SUBJECT: Three Phase, 12240 Volt Distribution line
Reference No: 1001294234/Hawes Twp/Alcona County/Lee

Subject: **UAC081574/CU-370**
12240 Volt Distribution Line
Section 20, Hawes Twp, Alcona County

**Project No: UAC081574
CU-370**

NOTIFICATION OF PROPOSED LINE CONSTRUCTION
REQUIRING COORDINATION WITH HVD AND/OR TRANSMISSION LINES

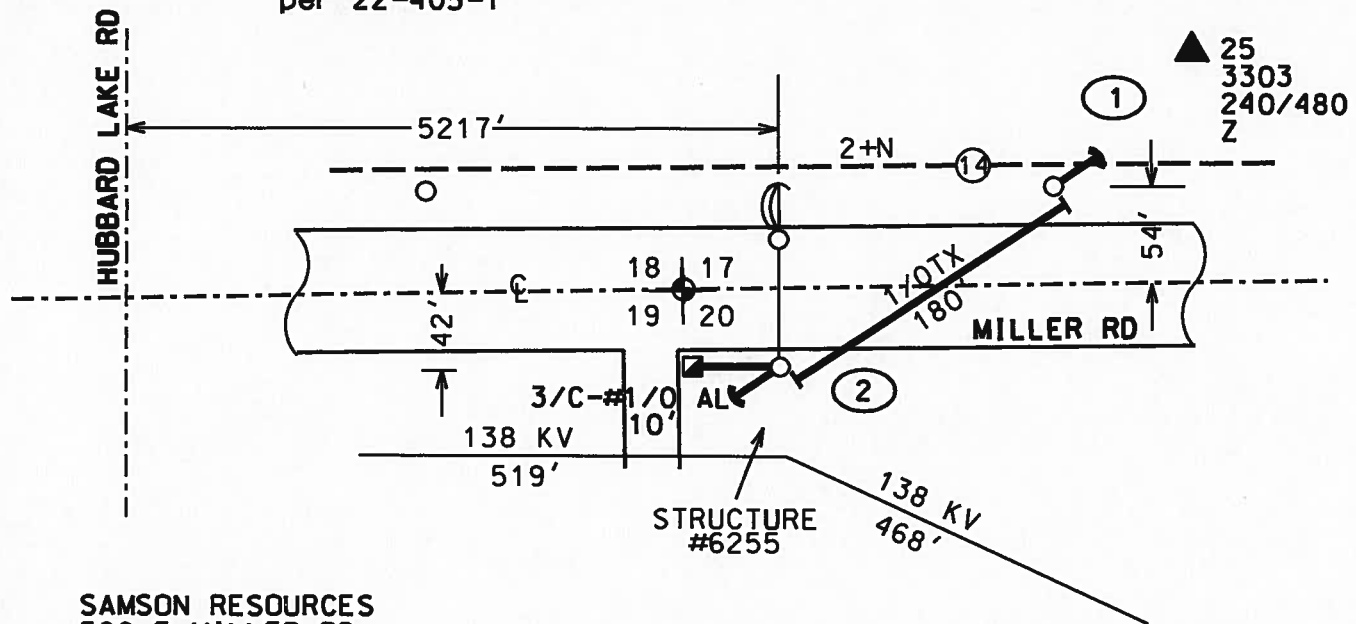
This request is approved. The close proximity of the fiber optic cable to the tower may present minor interference during maintenance or climbing of the tower. CE should consider that possibility. If it of no concern, METC is OK with its location.

Other Details: Both sags figured at attaching at 26' above ground. Minimum sag at 60 deg is 24.3'. Minimum sag at 32 deg is 24.7'. Distance from structure #6255 to Centerline of Miller Rd is 42'. UG riser is planned at 26' above final grade where oh tx attaches to structure. Add 11k guy with 10' guy lead.
